**Explanation of Significant Differences
for the
100-HR-3 and 100-KR-4 Operable Units
Interim Action
Record of Decision**

**Hanford Site
Benton County, Washington**

August 2009

INTRODUCTION TO THE SITE AND STATEMENT OF PURPOSE

Figure 3. 100-D Area Chromium Plume Conceptual Site Model 1995-2007

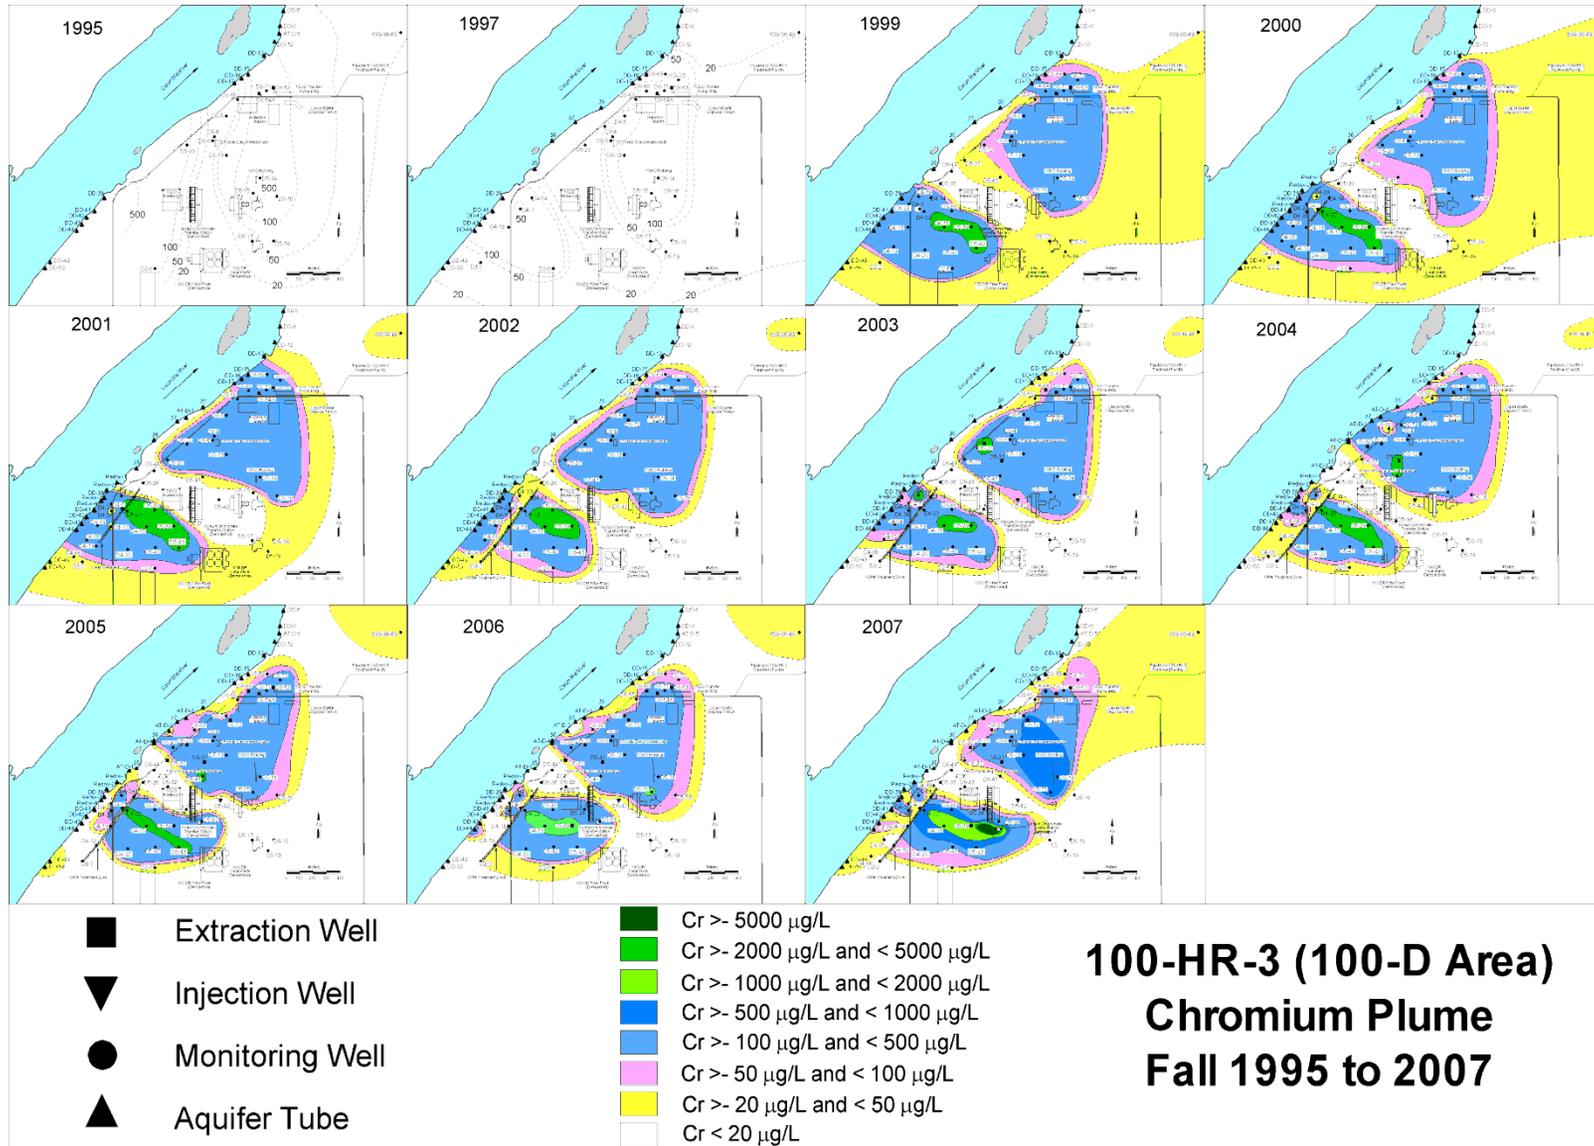
The hexavalent chromium plumes in 100-HR-3 have increased in concentration at the 100-D Area (Figure 3), and have migrated across the Horn Area towards the 100-H Area (Figures 4 and 6). This has required expansion and additions to the pump-and-treat system at 100-HR-3. Process system performance improvements were also implemented in FY2004.

Figure 5. 100-K Area Chromium Plume Conceptual Site Model 1997-2007

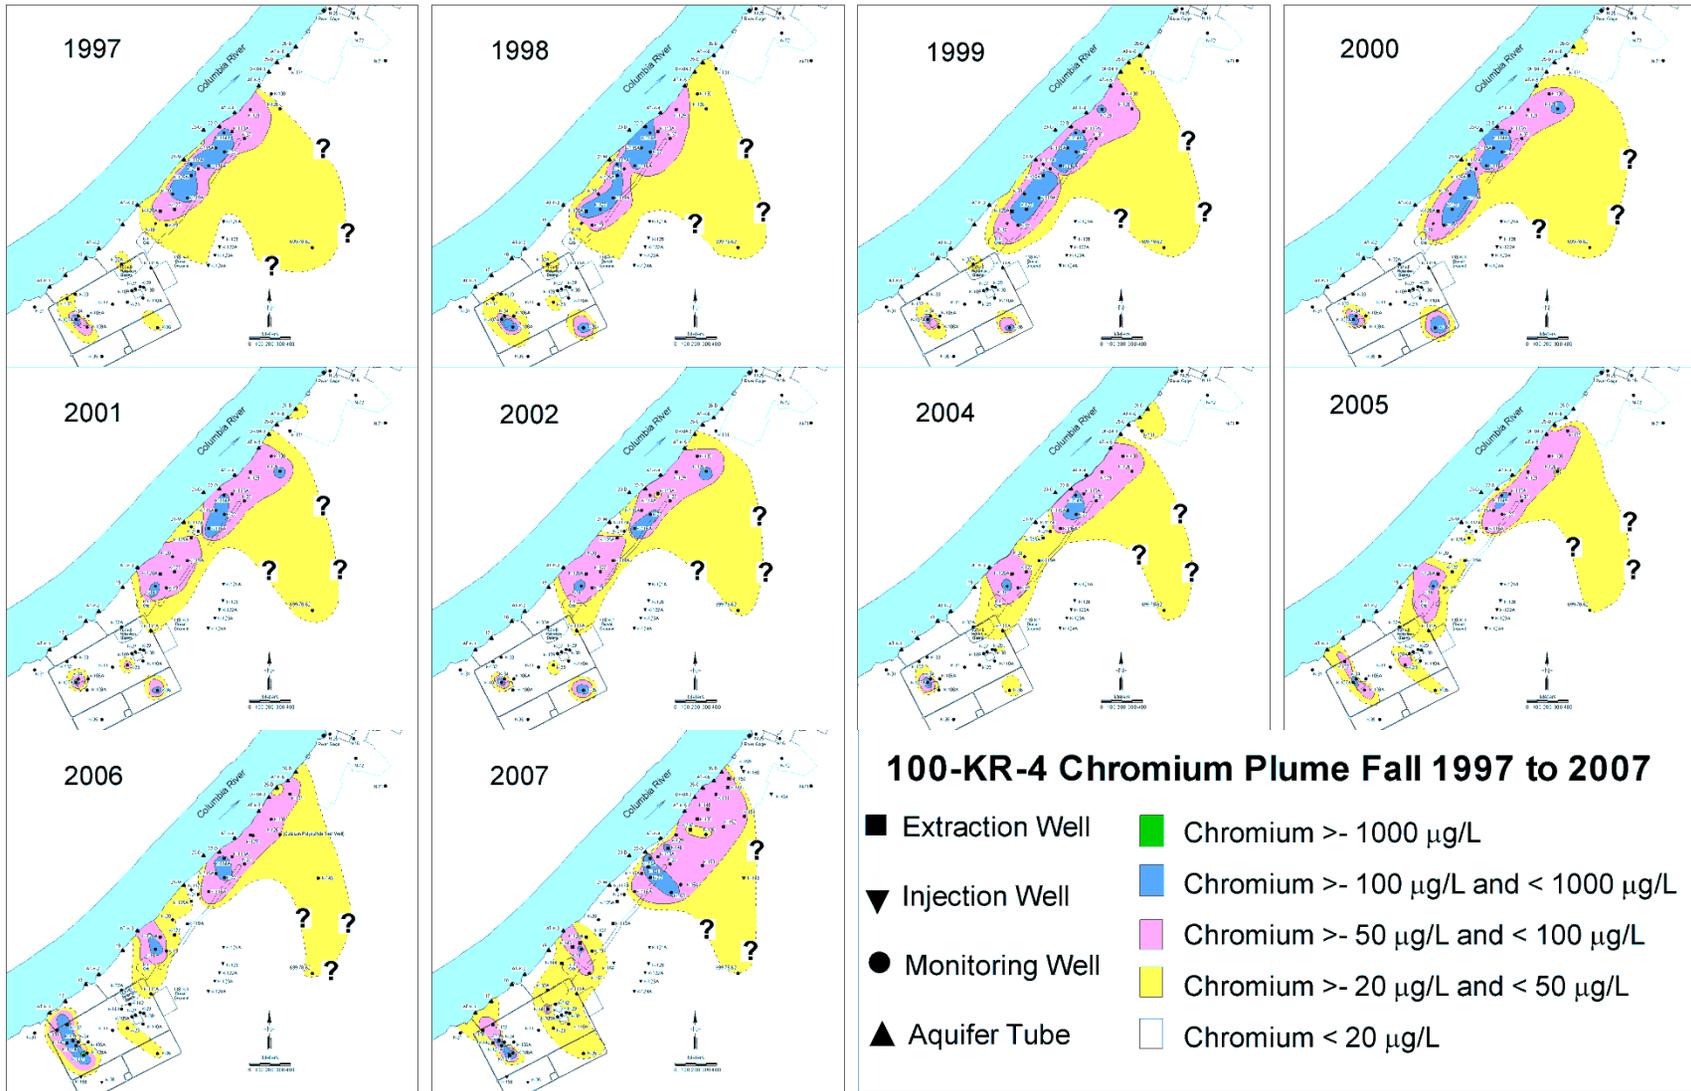
The 100-KR-4 hexavalent chromium plume has expanded to the NE (Figure 5), and the hexavalent chromium concentrations in the groundwater have increased, which required expansion of the pump-and-treat system. The existing treatment system has been expanded to 900 gpm compared to the 220 gpm identified in the 1996 ROD. An expanding plume has developed in the area of the K West reactor. A separate pump-and-treat system was installed in 2007 to remediate that plume. The new 200 gpm treatment capacity for K West began operation in FY09 and will result in increased cost reflected in this ESD. In addition, system performance improvements were implemented, which also increased the cost of the total project.
